10/517,642

<b>Office Action Summary</b>	<b>Application No.</b> 10/517,642	<b>Applicant(s)</b> DALUM, HANS JORGEN	
	<b>Examiner</b> MICHAEL P. FERGUSON	<b>Art Unit</b> 3679

3. Claims 11-13 and 16-22 are rejected under 35 U.S.C. 102(b) as being anticipated by Benson (US 4,135,372).

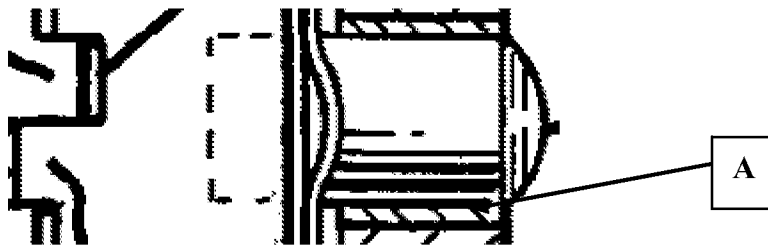
two first objects **A** (pair of bearings **A**; Figure 3 reprinted below with annotations), each having a bore **48,50**,

an attachment means **36,38** extending through said bores and assembling, in order, one of the first objects, the second object and the other first object into a unit, the two first objects being secured to the pipe within the openings in the rim of the pipe, the pipe providing a mechanical tension which is transferred as compressive forces in the longitudinal direction of the attachment means to the second object (spring washers **44,46** exert a compressive force on second object **20,22**. Clearly, an opposing tension force must exist within the material of pipe rim **56,58** in order to provide a resistance force to enable such relative compression force), the second object forming a link part rotatable relative to the two first objects, having an axis of rotation along the longitudinal axis of the attachment means (Figures 1-3).

one or more pairs of apertured discs **44,46,59,60**, each respective apertured disc of each pair of apertured discs being disposed on a respective side of the second object **20,22,12** between the second object and one of the first objects **A**, the attachment means **36,38** extending through a hole in the apertured discs (Figure 3).

As to claim 13, Benson discloses a rotatable link wherein two or more pairs of apertured discs **44,46,59,60** are provided (Figure 3).

As to claim 22, Benson discloses a method comprising providing one or more pairs of apertured discs **44,46,59,60**, and, disposing each respective apertured disc of each pair of apertured discs on a respective side of the second object **20,22,12** between the second object and one of the first objects **A**, the attachment means extending through a hole in the apertured discs (Figure 3).

As to claims 14 and 15, Benson discloses a rotatable link wherein two pairs of apertured disks **44,46,59,60** are provided (Figure 3). Benson fails to disclose a rotatable link wherein four pairs of apertured disks are provided. Benson does not
